PART 21 REPORT - SERIES 20 MODULE MAY ALLOW THE SIDE COVER TO TOUCH THE WIRE INSULATION

Subject: 10 CFR Part21 Reporting of Defects and Noncompliance
Electroswitch Report # 10CFR21-????????? 50504

Electroswitch	NON CONFORMANCE REPORT	Rev: J	Document no: NONCON-1 CAR #14-001 Rev. A
---------------	-------------------------------	-----------	---

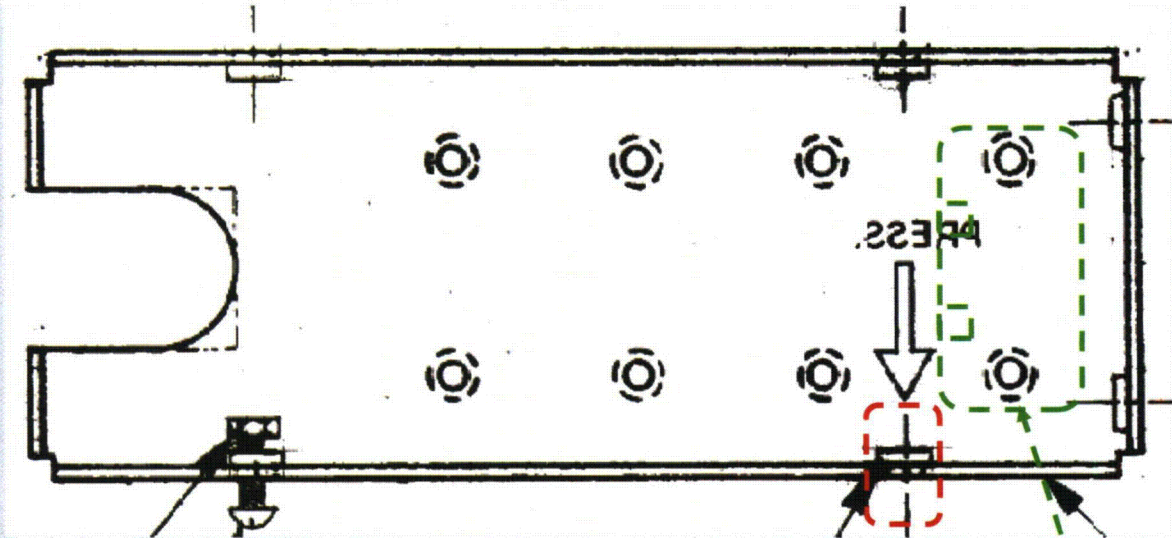
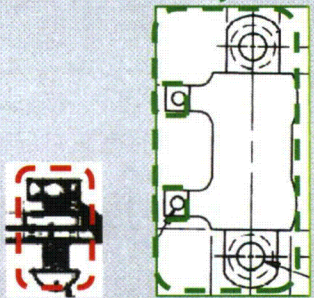
Location and length of screw in relation to location and length of resistor terminal on top panel do not allow for any interference. Orientation of wire to terminal could allow screw to touch wire insulation. Short could only occur if screw penetrates insulation or insulation is stripped to far back.

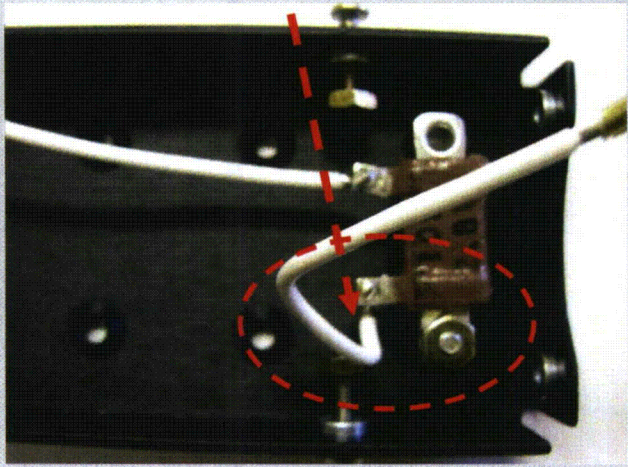
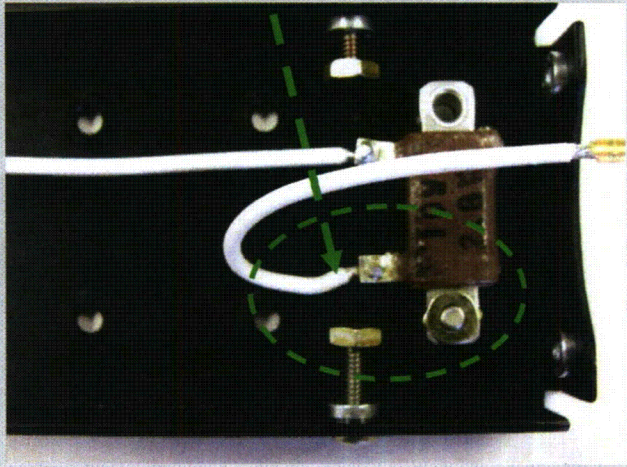
Incorrect orientation

Correct orientation

To prevent possibility of cover screw having contact with the wire attached to the resistor.
